Access Compliance Report

Public Rights-of-Way

(Curb Ramps)

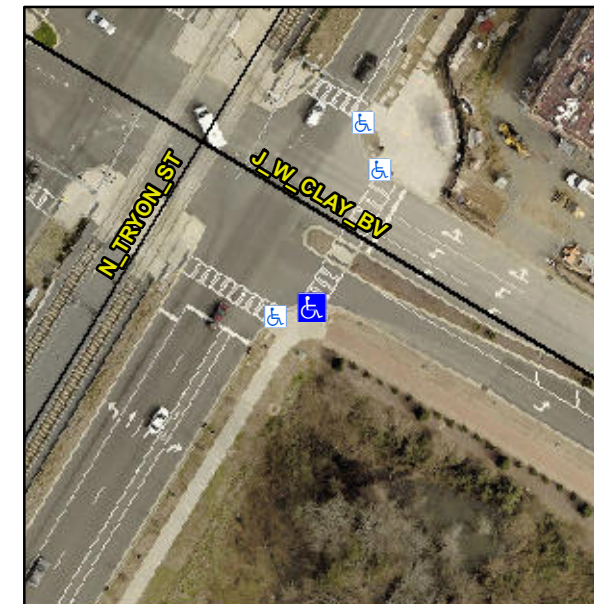
Intersection ID: 5468	Main Street: N_TRYON_ST	Cross Street: J_W_CLAY_BV	Location: S
ADA ID: F51AC7ED2709	Ramp Type: Perp	Initial Pass/Fail: Fail	Overall Compliance: No
Severity Score: 35			
Codes/Mitigation Info/Possible Solution		Field Measurements/Component Compliance

R304.5.1, R304.2.2

Compliance	Description	Data	Compliance	Description	Data
N/A	Ramp Length (in)	98.0	No	Ramp Slope (%)	20.0
No	Ramp Width (in)	46.0	Yes	Ramp XSlope (%)	3.4
N/A	Flare Type LT	N/A	N/A	Flare Type RT	N/A
N/A	Flare Slope LT (%)	N/A	N/A	Flare Slope RT (%)	N/A
N/A	Flare Traversable LT?	N/A	N/A	Flare Traversable RT?	N/A
N/A	Landing Length (in)	N/A	N/A	DWS Provided?	N/A
N/A	Landing Width (in)	N/A	N/A	DWS Contrast?	N/A
N/A	Landing Slope (%)	N/A	N/A	DWS Length (in)	N/A
N/A	Landing X Slope (%)	N/A	N/A	DWS Full Width?	N/A
N/A	Landing Curb? (Y/N)	N/A	N/A	DWS Offset (in)	N/A
N/A	Shared Landing?	N/A			
N/A	Gutter Ponding?	N/A	N/A	Gutter Slope (%)	N/A
N/A	Gutter Lip Ht (in)	1.0	N/A	Gutter X Slope (%)	N/A
N/A	Painted X Walk1?	No	N/A	Painted X Walk2?	N/A
	X Walk 1 Direction	To NE		X Walk 2 Direction	N/A
N/A	X Walk 1 Width (in)	N/A	N/A	X Walk 2 Width (in)	N/A
	X Walk 1 Slope (%)	4.0		X Walk 2 Slope (%)	N/A
	X Walk 1 X Slope (%)	5.2		X Walk 2 X Slope (%)	N/A

Remove & Replace Entire Ramp.
